THE BRIDGES - PHASE 1

PRELIMINARY CONSTRUCTION DOCUMENTS EDEN, WEBER COUNTY, UTAH

THE BRIDGES - PHASE 1
PRELIMINARY CONSTRUCTION DOCUMENTS

DR1
 25

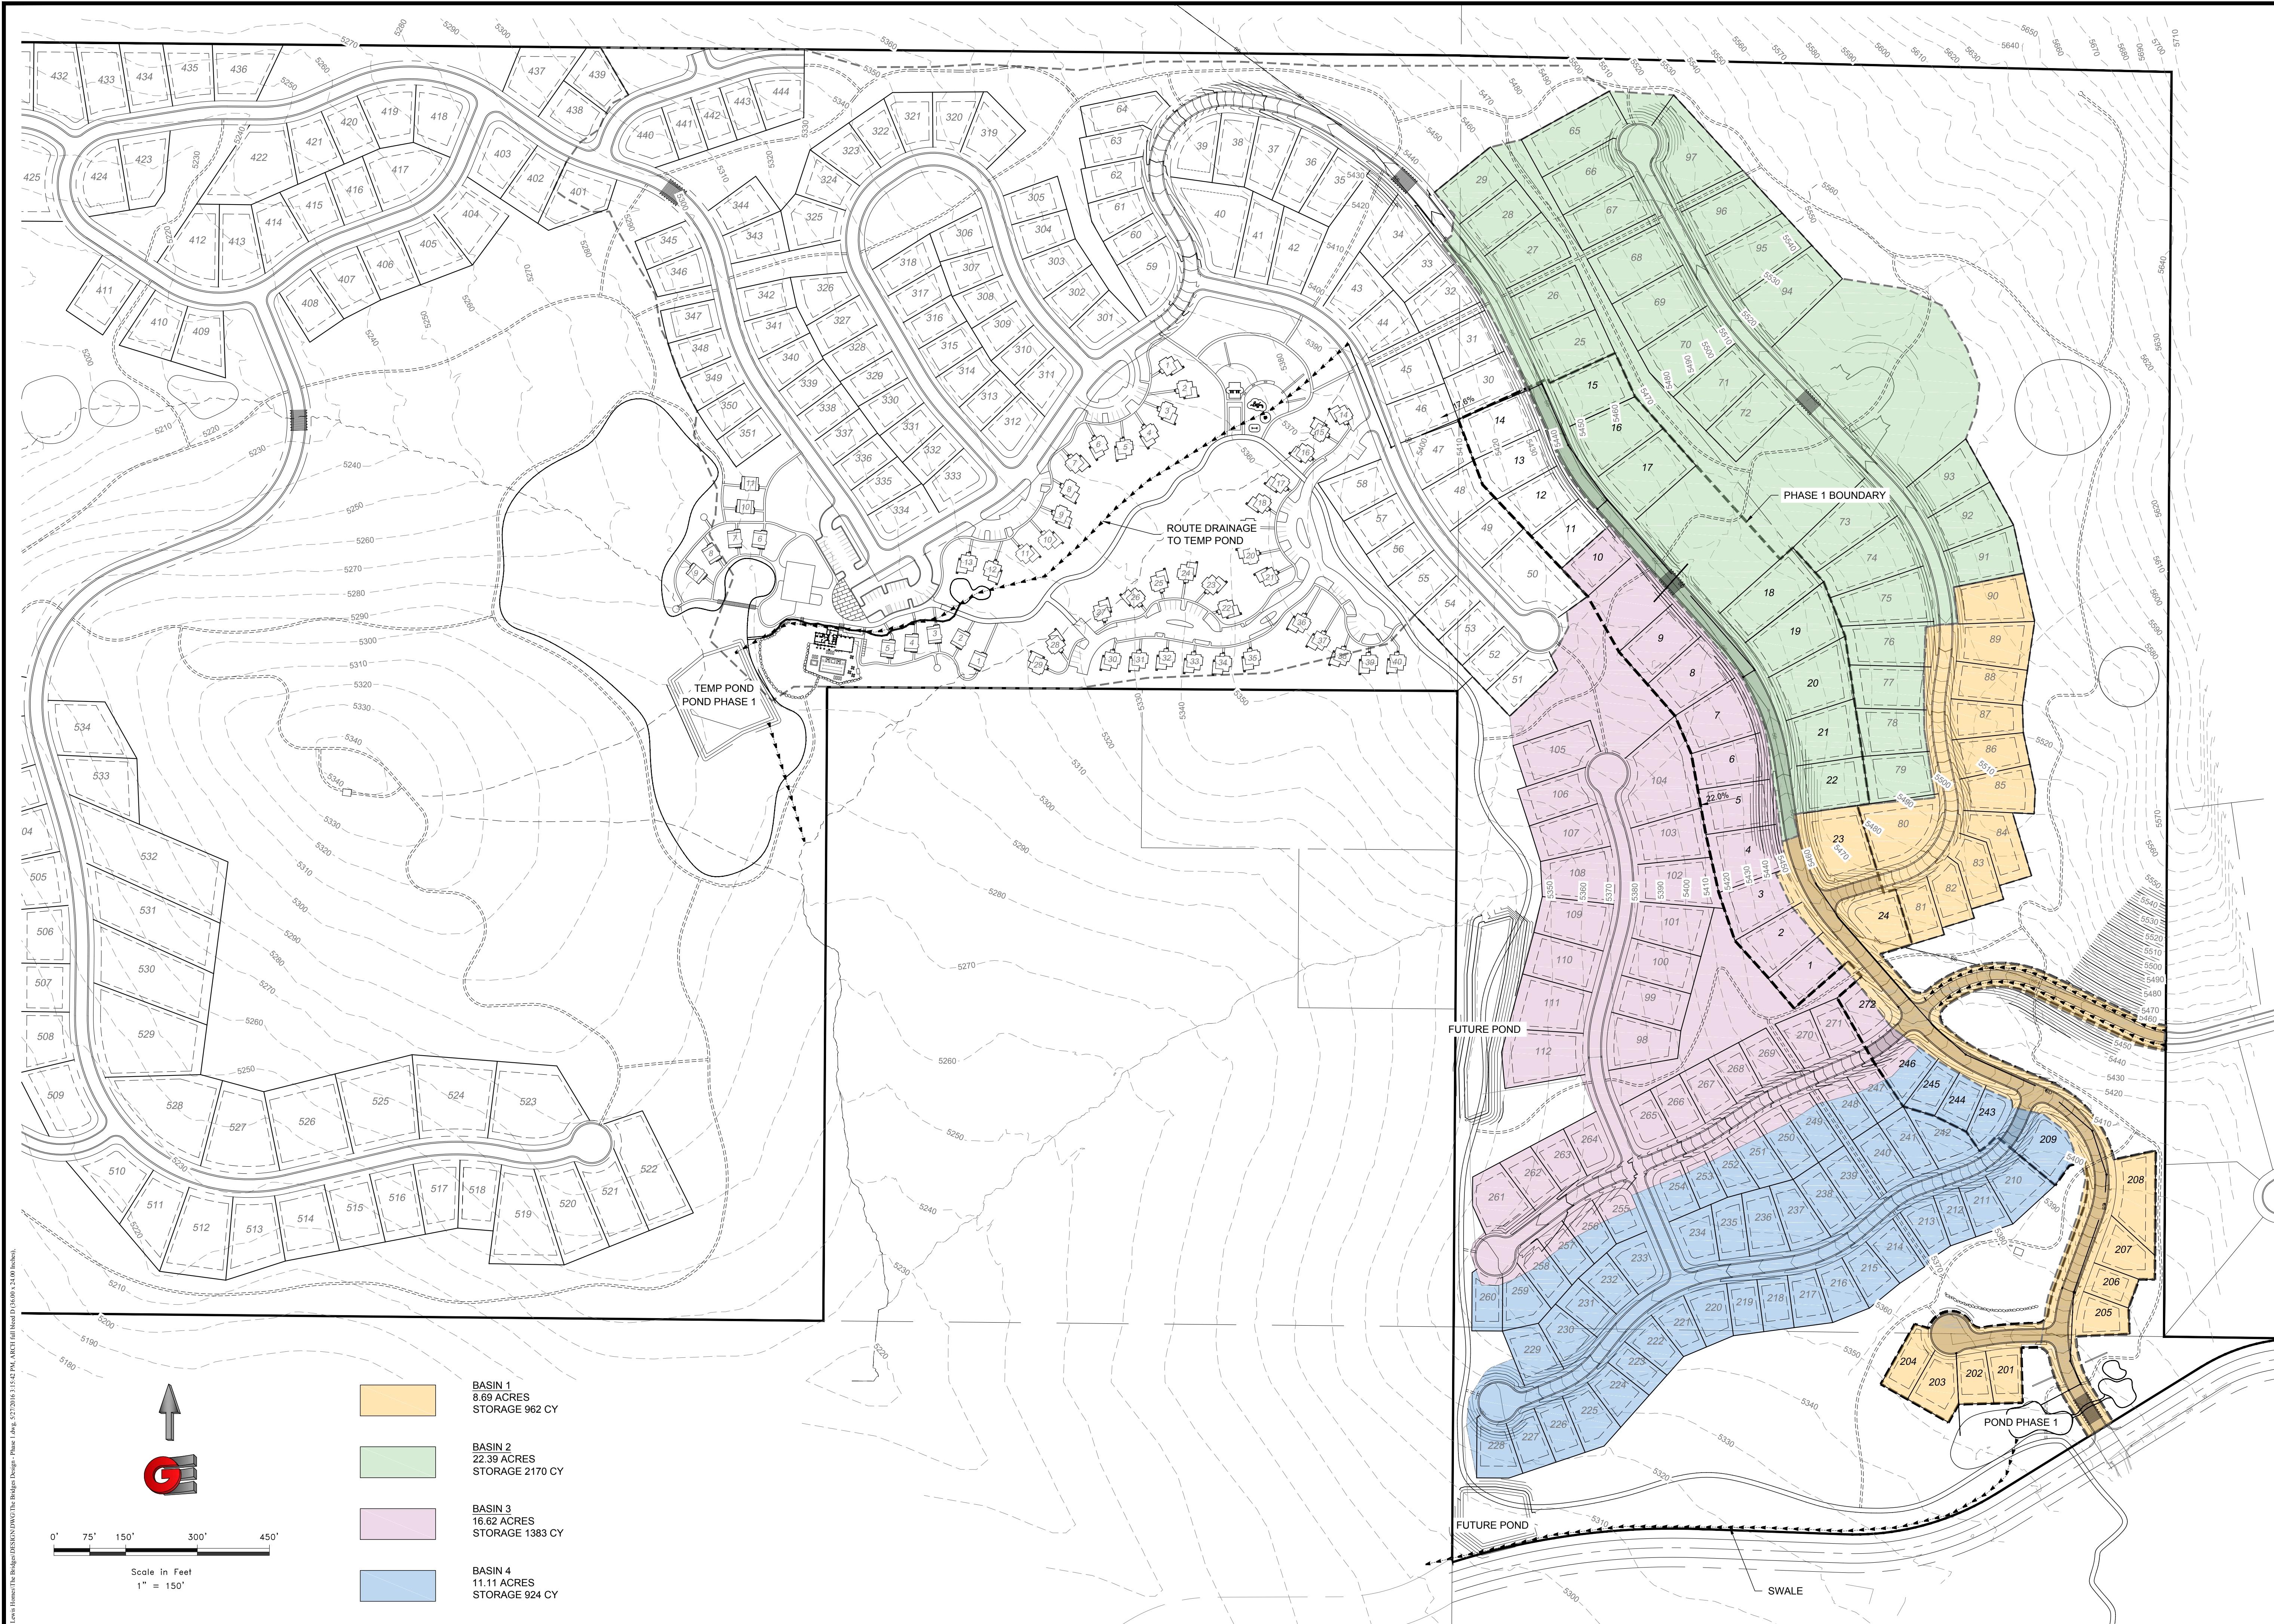
Are there easements for this drainage??

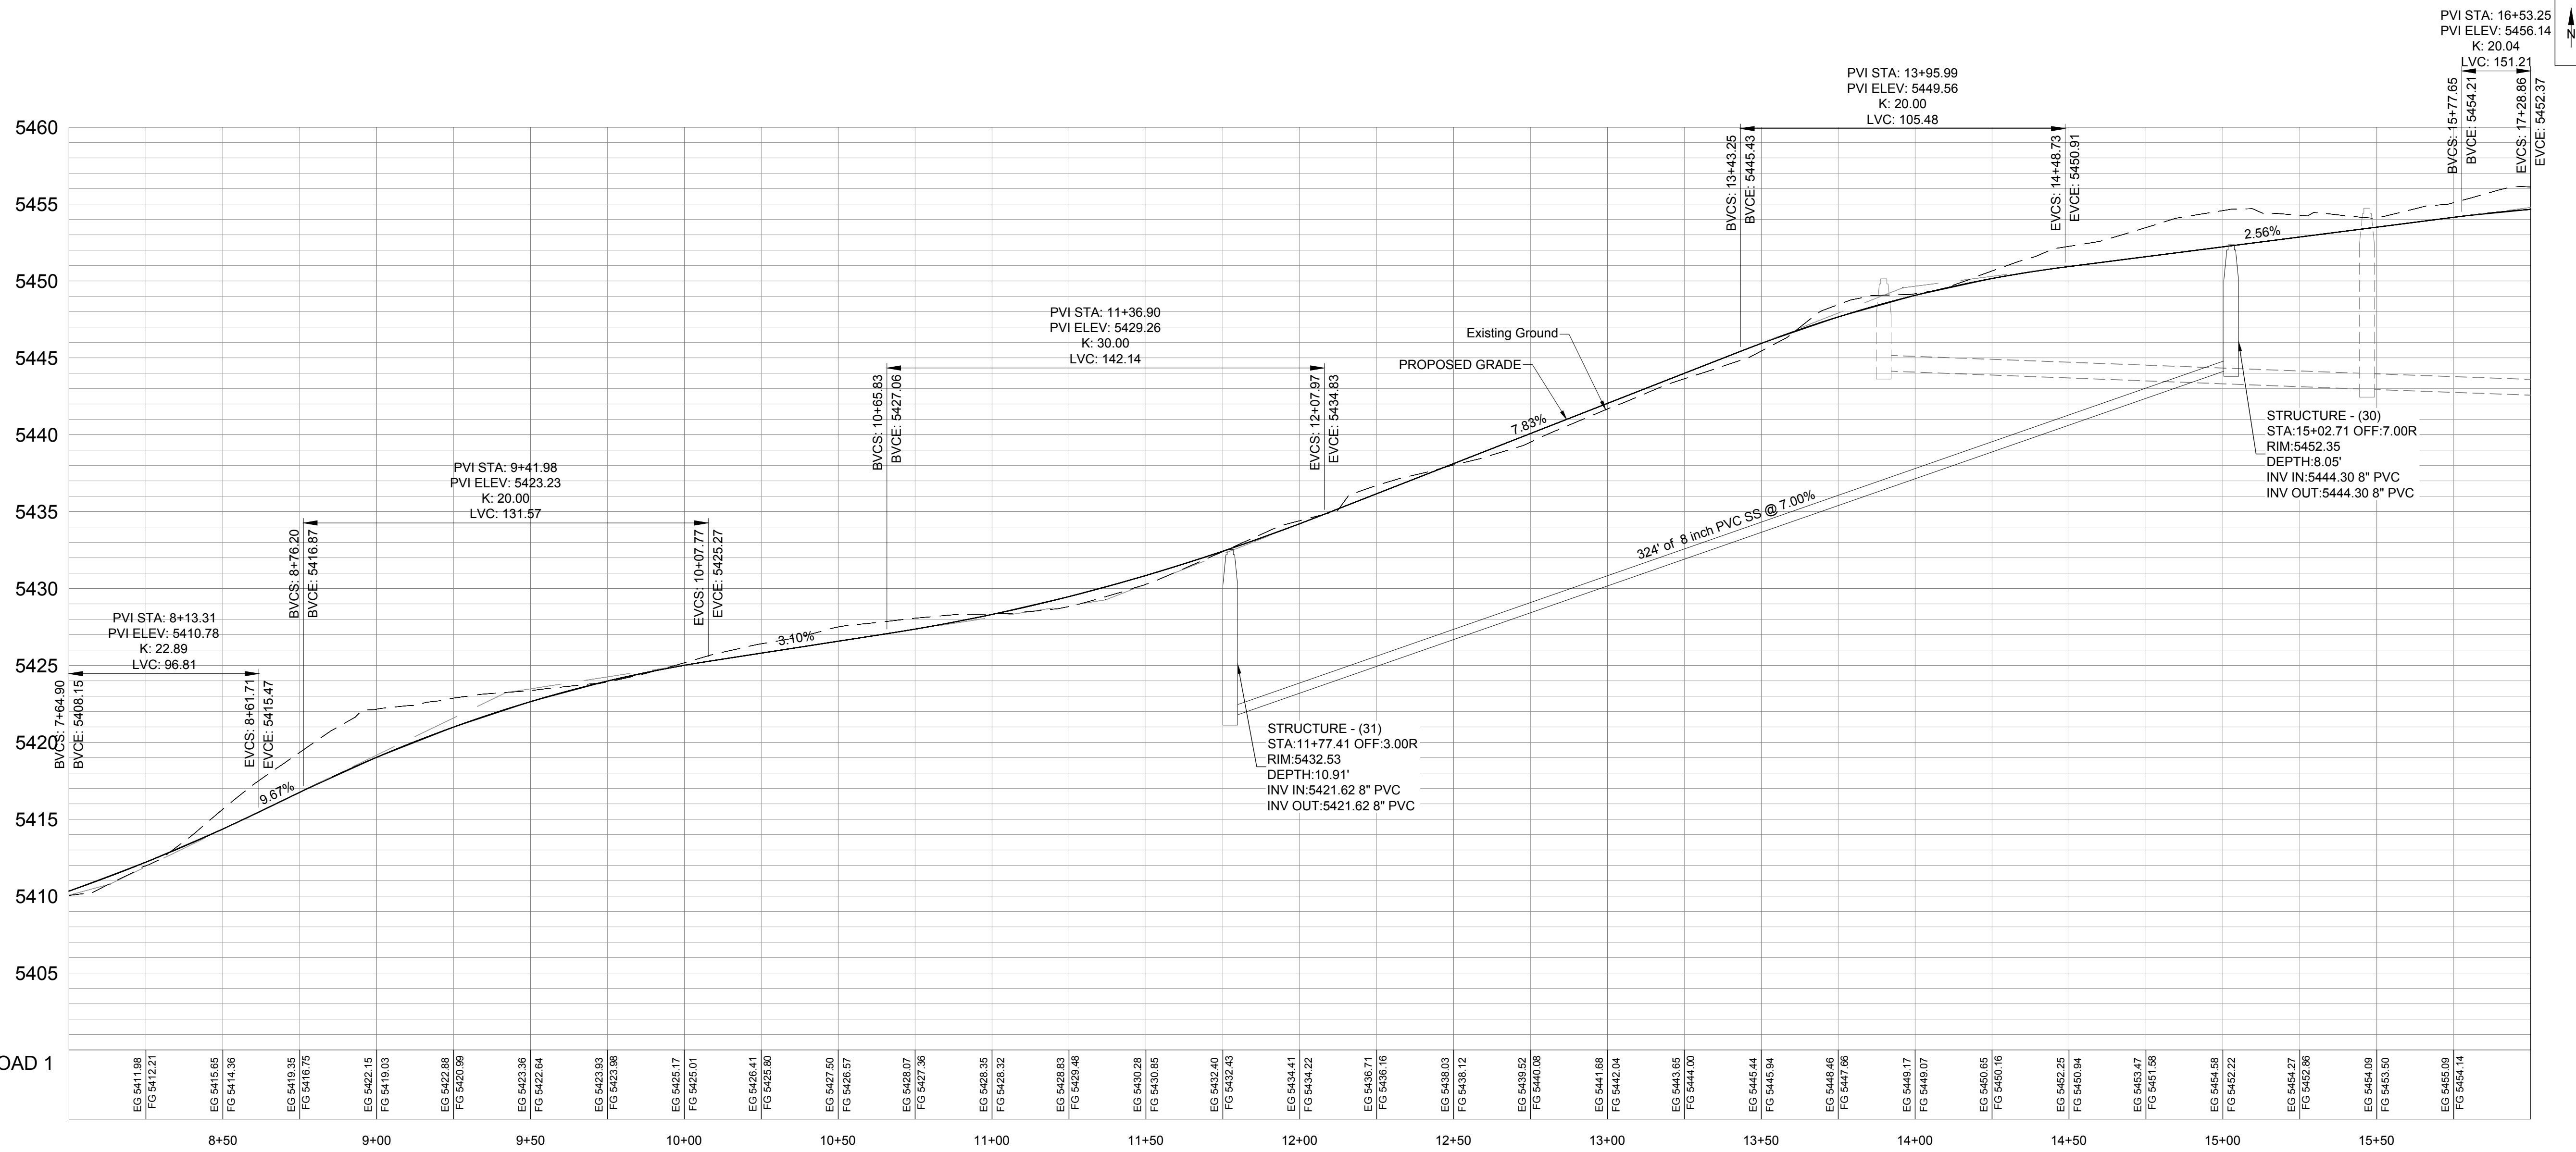
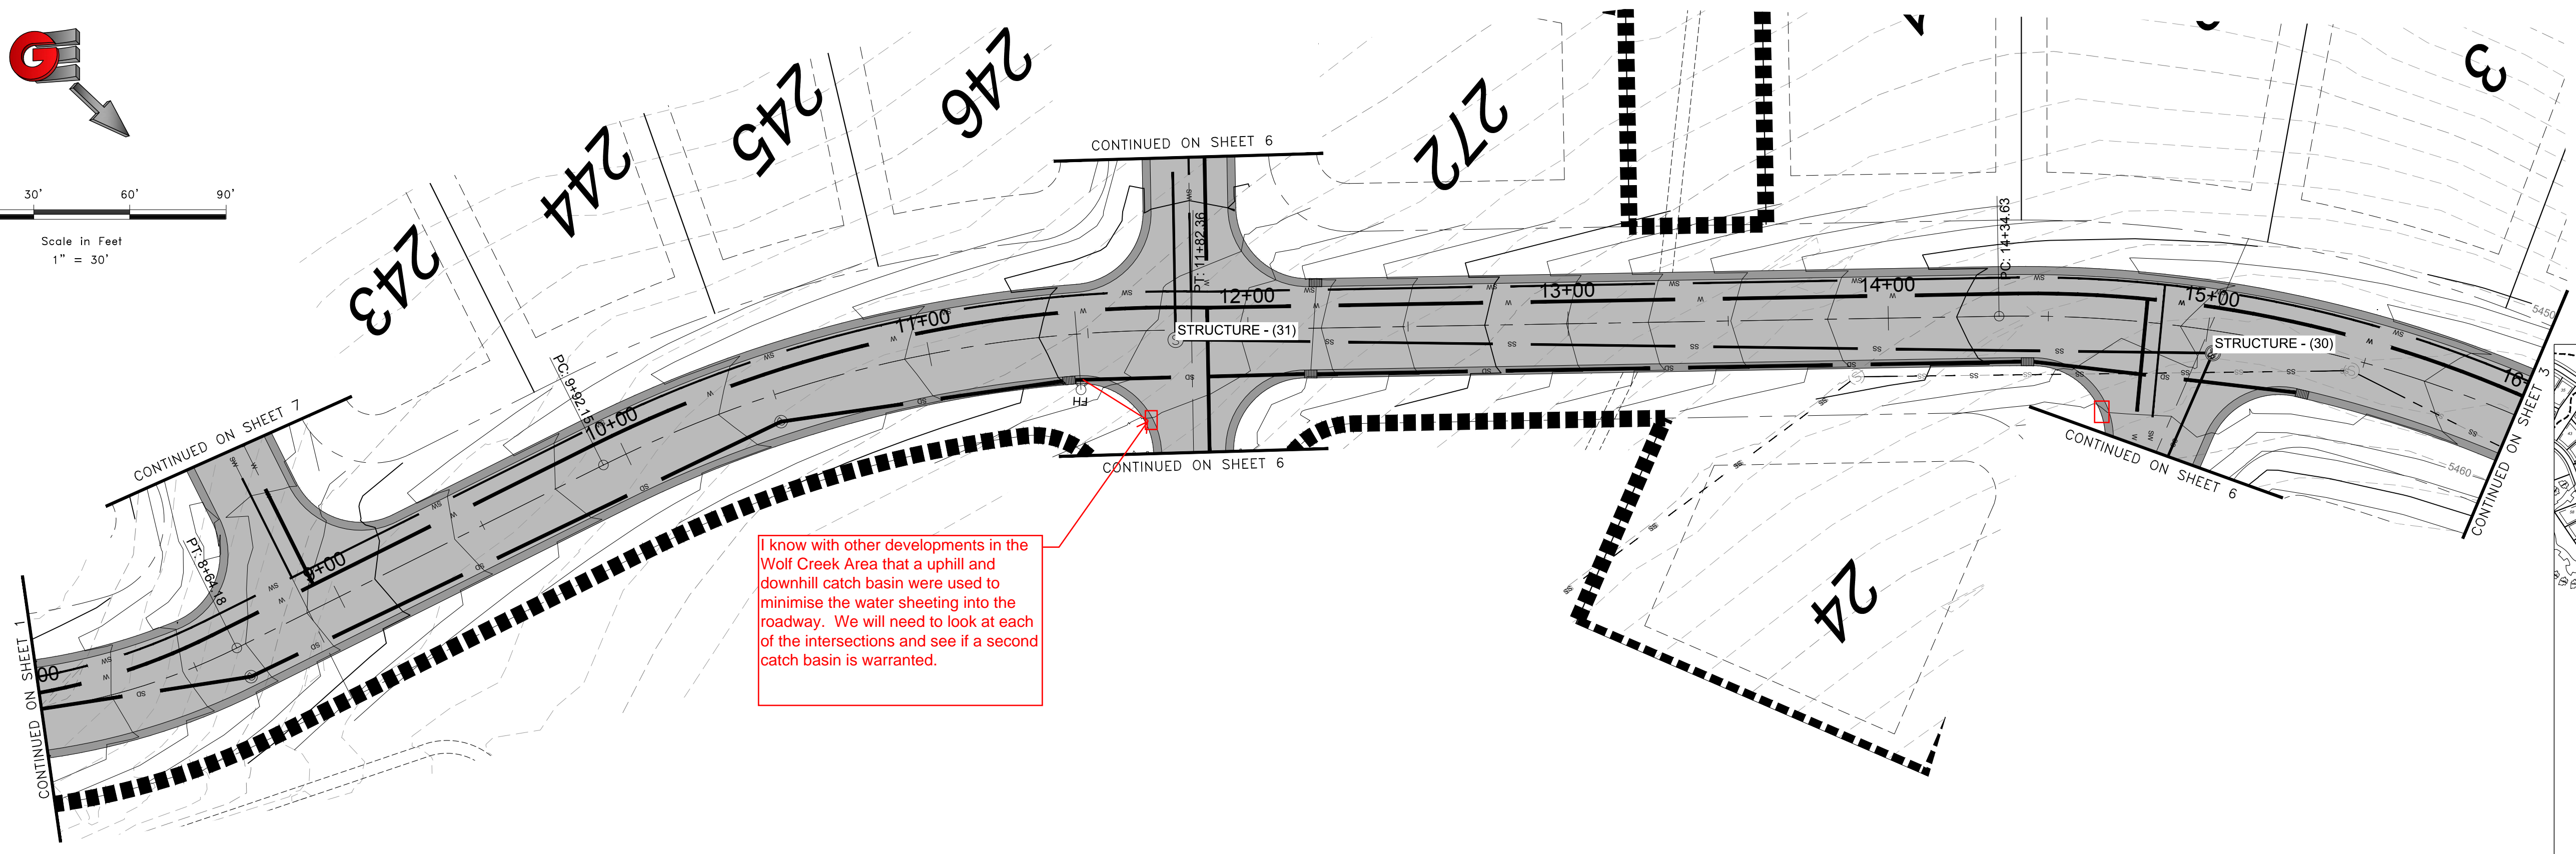
I know with other developments in the Wolf Creek Area that an uphill and downhill catch basin were used to minimise the water sheeting into the roadway. We will need to look at each of the intersections and see if a second catch basin is warranted.
